Product Change Notification

Date Issued :	February 28, 2024	PCN Number :	514903
Reason for Change :	Change to Product		
Description of Change :	<p>This notification is to inform you about changes that are being made to the part(s) as identified in the list. This change will not affect the Fit, Form, Function, or appearance of the parts. This does not affect the specification of the final assembly/finished good.</p>		
Assessment of Change :	Dimension analysis		
Planned Implementation Date :	September 13, 2024		
Customer Sample Availability Date:	June 14, 2024		
Last date to request Samples by Customer :	May 31, 2024		
<p>Please note if Samples are not requested as per Customer Samples Request date, it may take additional 4-6 weeks to arrange Samples.</p>			
Traceability Code Markings / Date :	Date code

LVDS

LVDS

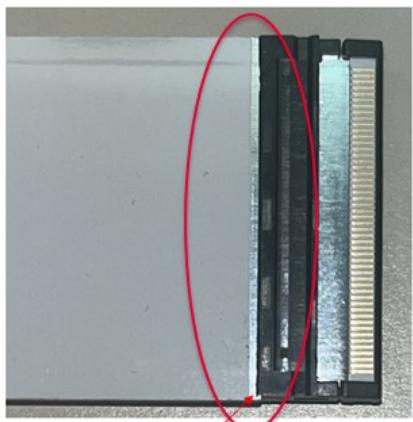
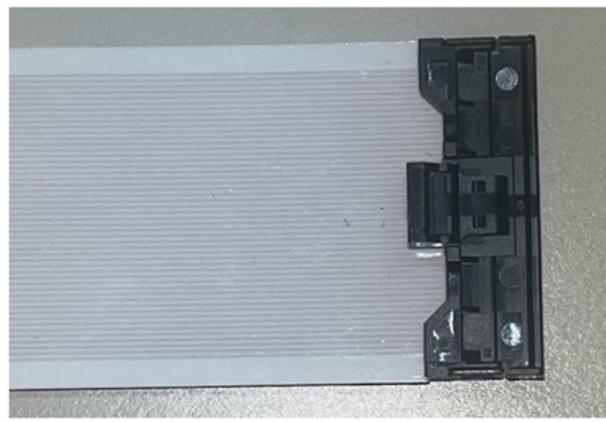
White jacket is pulled back so no interference with clips. This will call a small about of the shield to be exposed at the edge of the clips as seen above.

- White jacket is pulled back to reduce interference with clips. This causes a small amount of the shield to be exposed at the edge of the clips, see After Change slide for more details.
 - This was done to make clip assembly easier and to reduce interference.
- Product Impact
 - No impact to fit, form, or function.
- Part Number Impact
 - Premoflex series 15022
 - See attached impacted parts list.
